U.S. NUCLEAR REGULATORY COMMISSION

In the Matter of American Energy Co. LLC

D. Ashley - FW: Audit Q & A (Question Numbers AMP-141, 210, 356)

NRC Information Request Form

Sandbed Bay 19 Location B

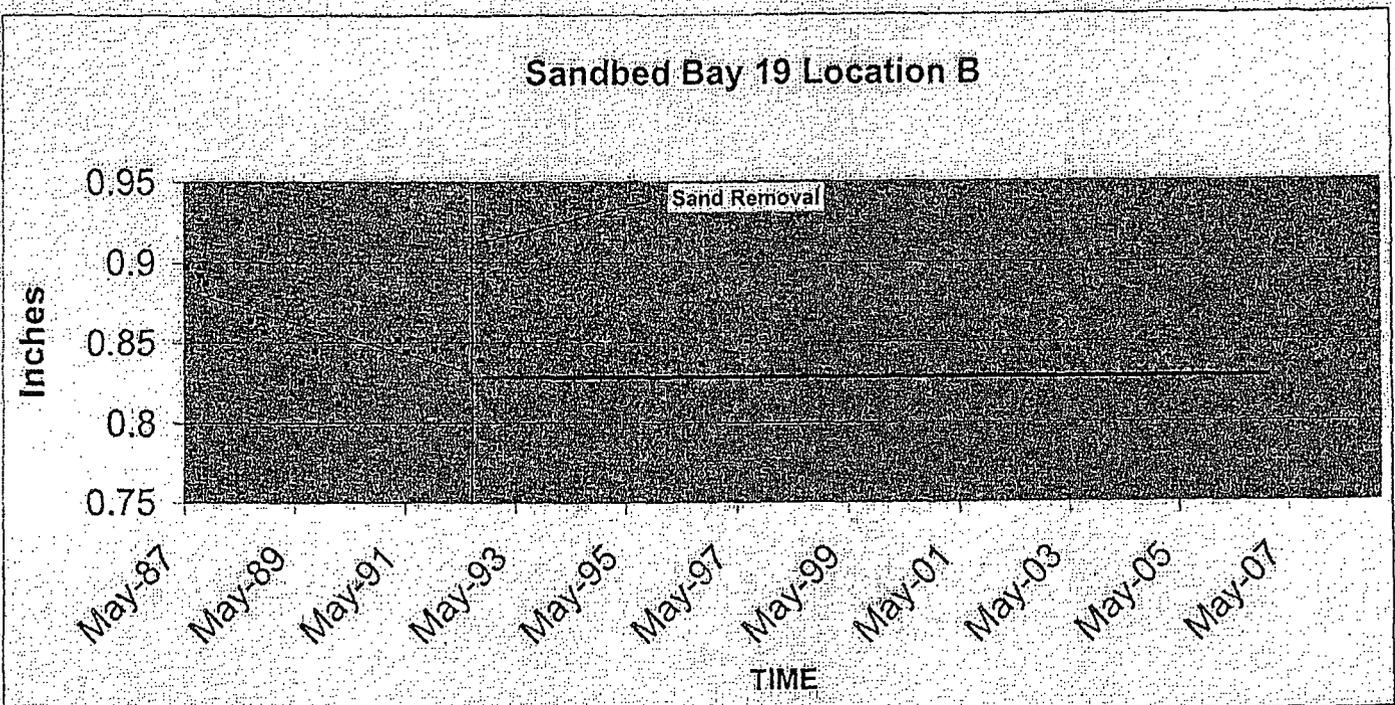
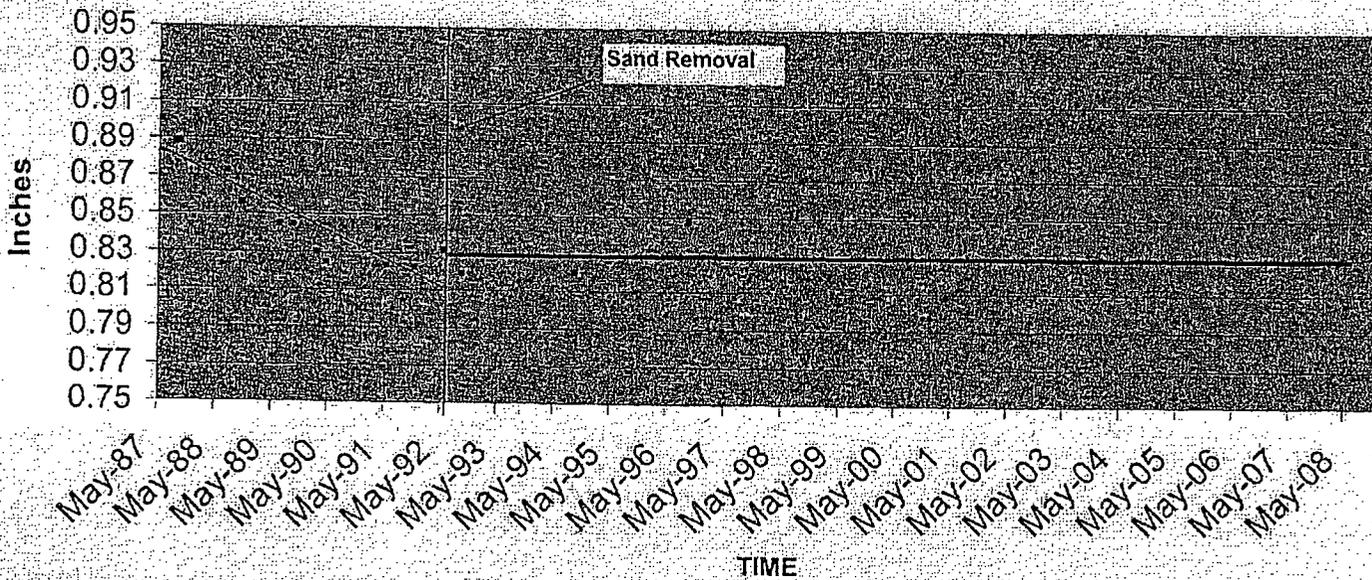
(3) For each grid location, submit a graph of remaining thickness versus time, using the UT readings since the initiation of the program (both prior to and following removal of the sand and application of the external coating).

3. A graph representing the remaining thickness versus time using UT reading since the initiation of the program (both prior to and following removal of the sand and application of the external coating) for location 9D, 11A, 11C, 13A, 13D, 15D, 17A, 17D, 17/19, 19A, 19B, and 19C is included in the attached graph. Other locations (i.e. 1D, 3D, 5D, 7D, 9A, 13C, and 15A) are not included because wall thinning is not significant and the trend line will be essentially a straight line.
